C2PC Request Letter

Class II permissive change for **FCC ID: 2AXJ4EAP650V2**

Applicant: TP-Link Corporation Limited

EAP650, EAP653	Festa F65

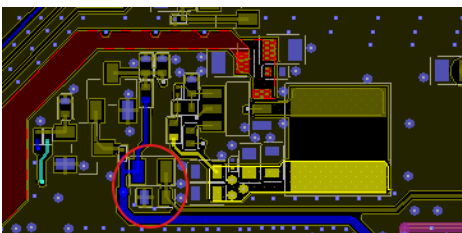
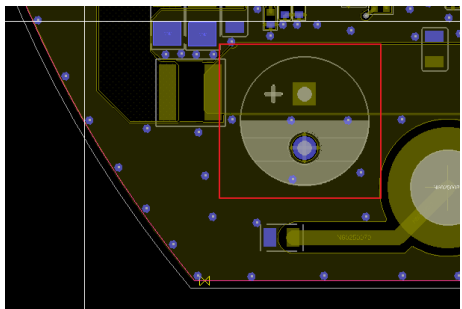
1. Add “Festa F65” in model names, the difference with previous models “EAP650, EAP653 is the shell, as below:

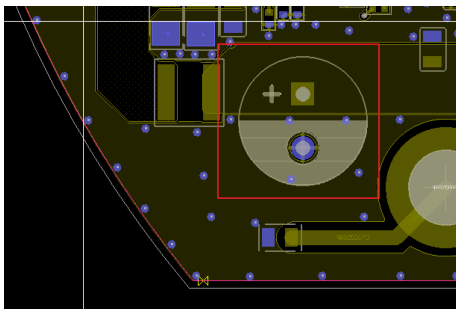
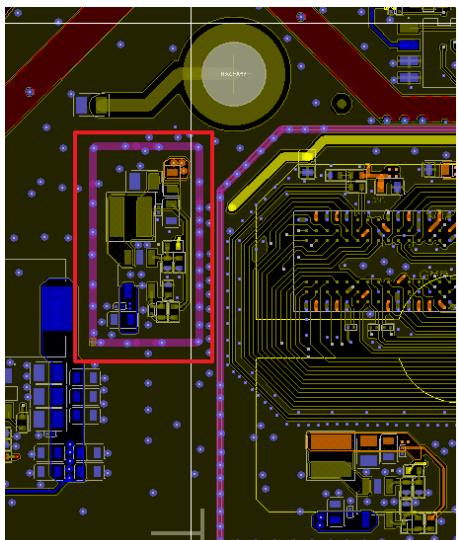
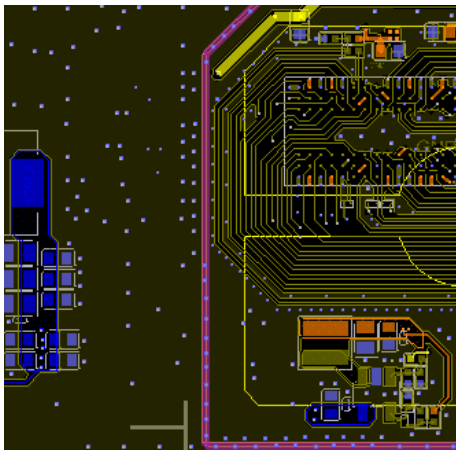
2. PCB Modifications

PCB (Original)	PCB (New version)	Description
Placement	 	 	Change the position
PCB Layout			Traces are combined
Electron component	 	 	Add and delete the reserved circuit
